CITY OF ALBUQUERQUE

RE: **Lot 31 Block 5 Unit 5 SAD 227**
8036 Victoria Dr. NW
Grading and Drainage Plan
Engineers Stamp Date 10/18/19 (E10D067)
Pad Certification Date 12/16/19

DRAINAGE AND TRANSPORTATION INFORMATION SHEET (REV 6/2018)

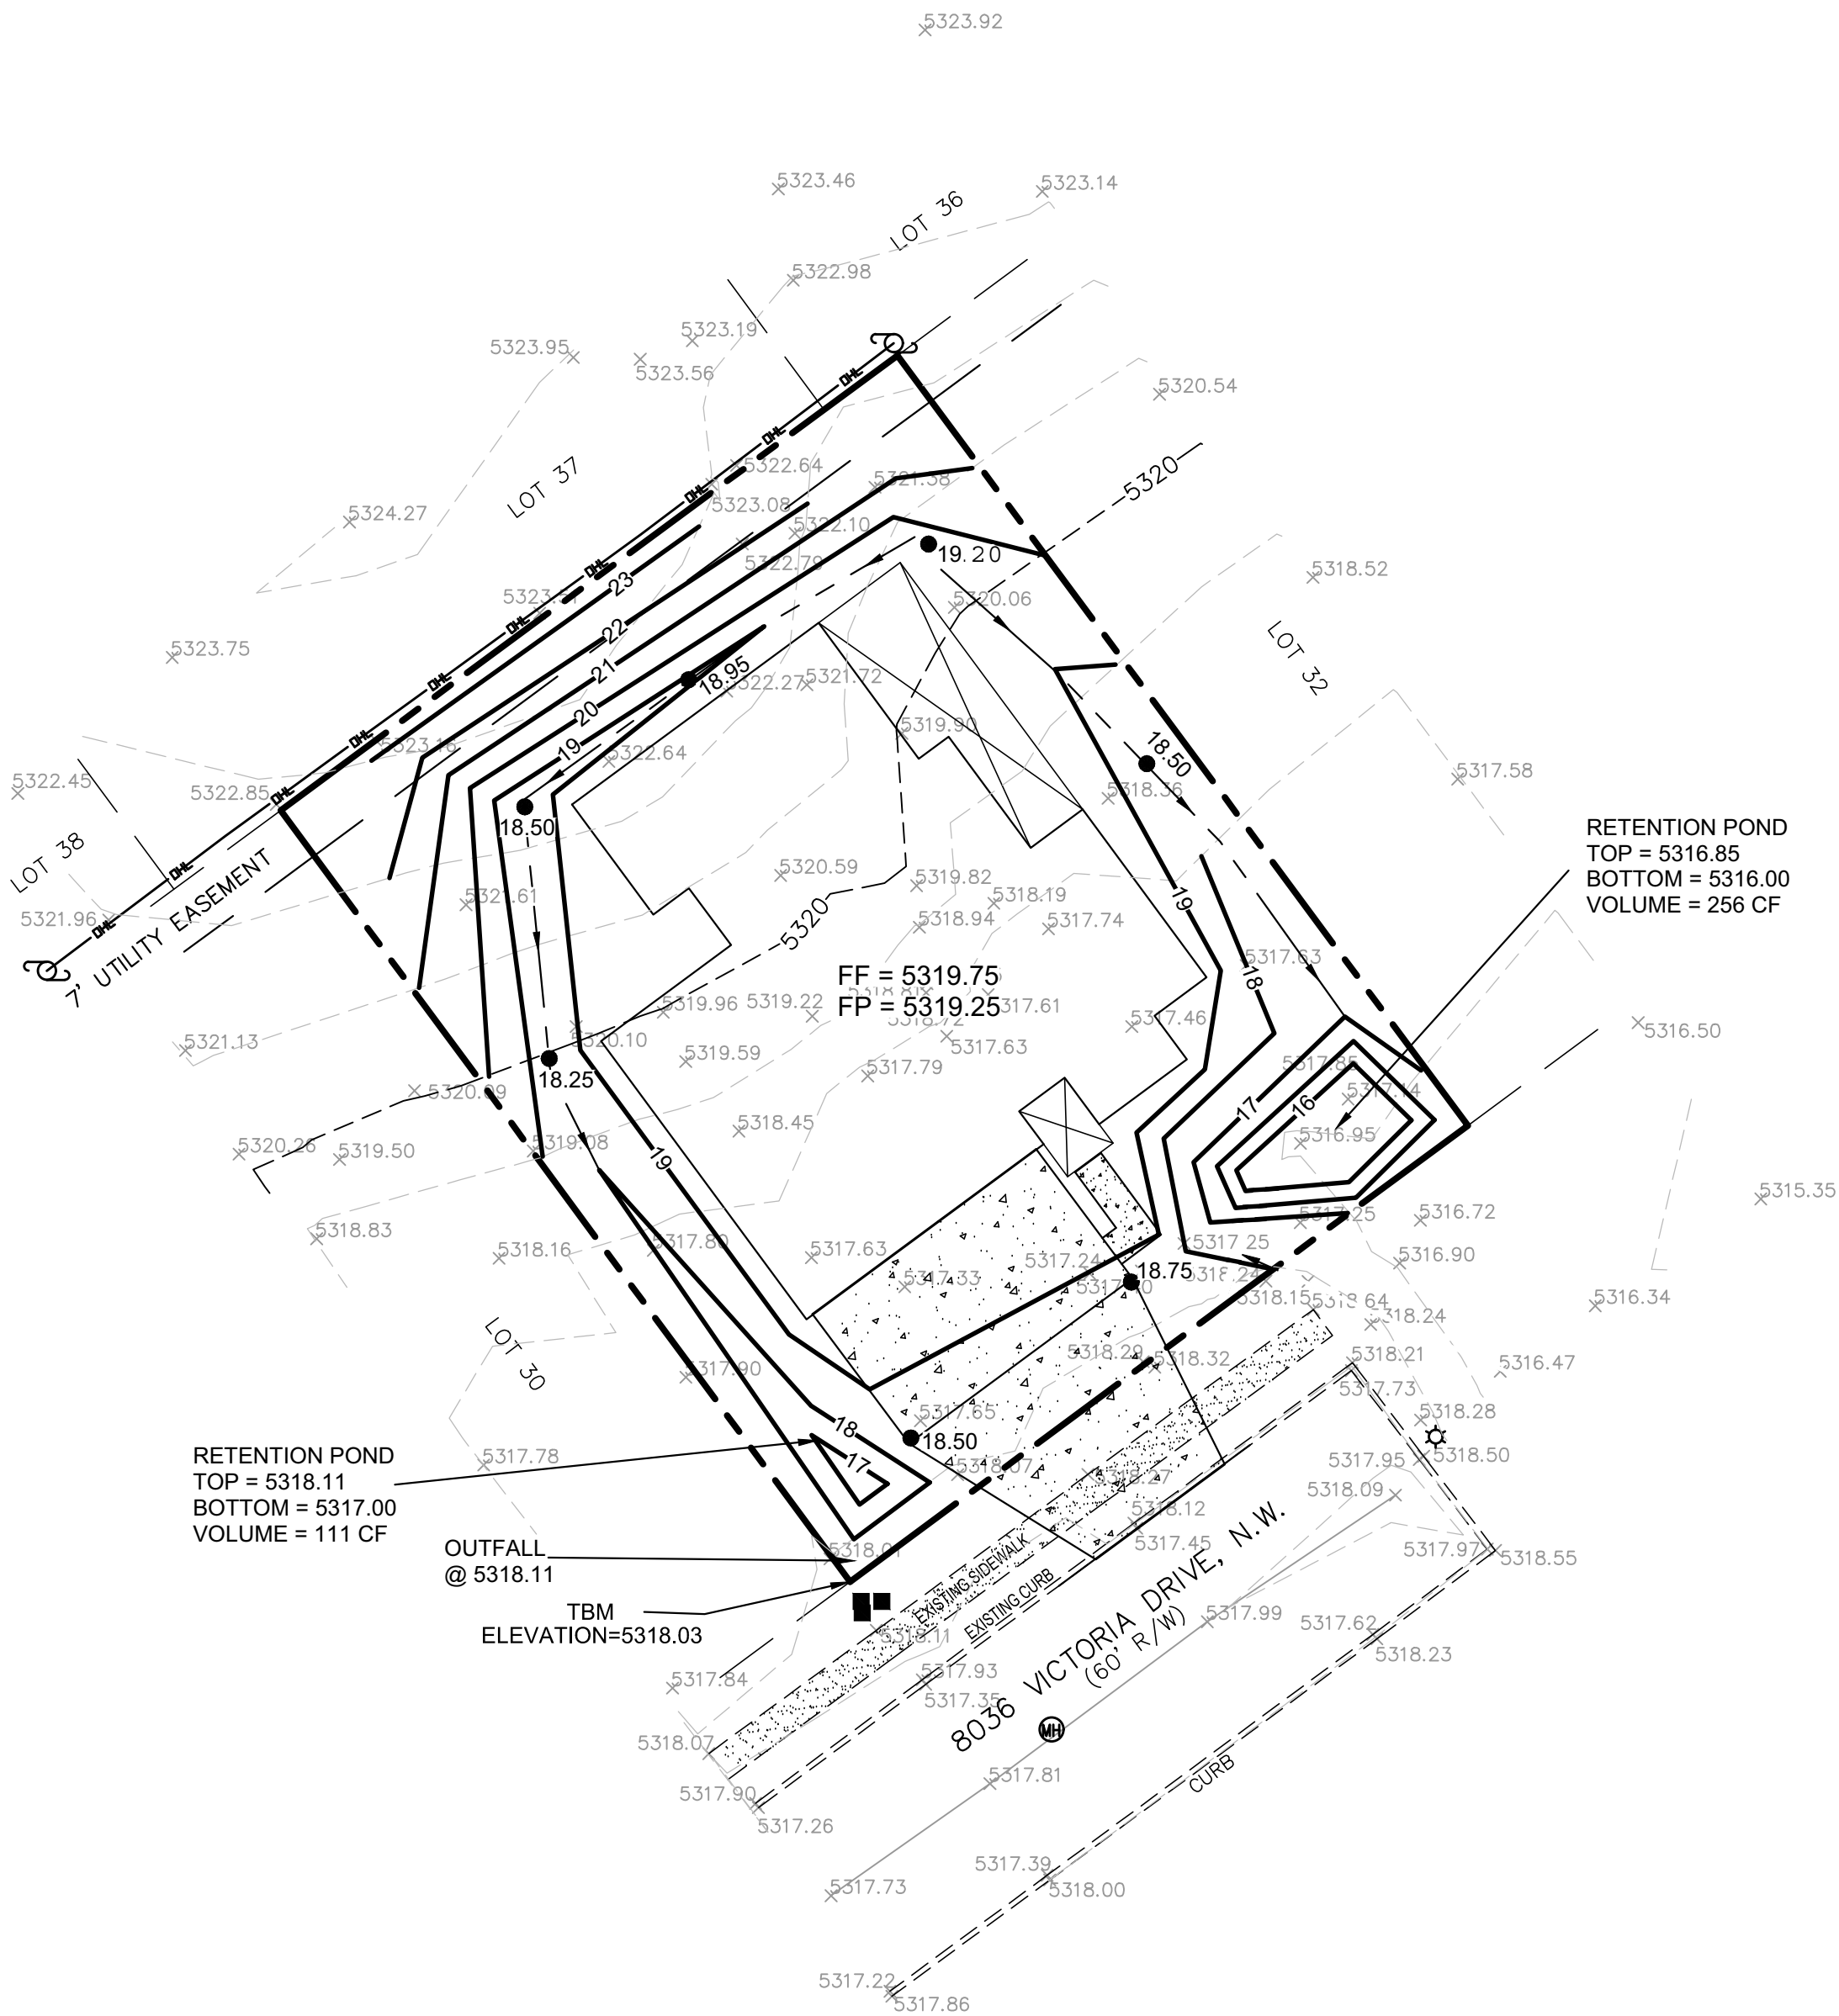
Based upon the information provided in your submittal received 12/16/19, this plan is approved for Building Permit.

Reiterate to the Owner/Contractor that a separate permit for a garden/retaining wall must be obtained, with the approved G&D plan dated 10/18/19.

Prior to Certificate of Occupancy release, Engineer Certification per the DPM checklist of this plan will be required.
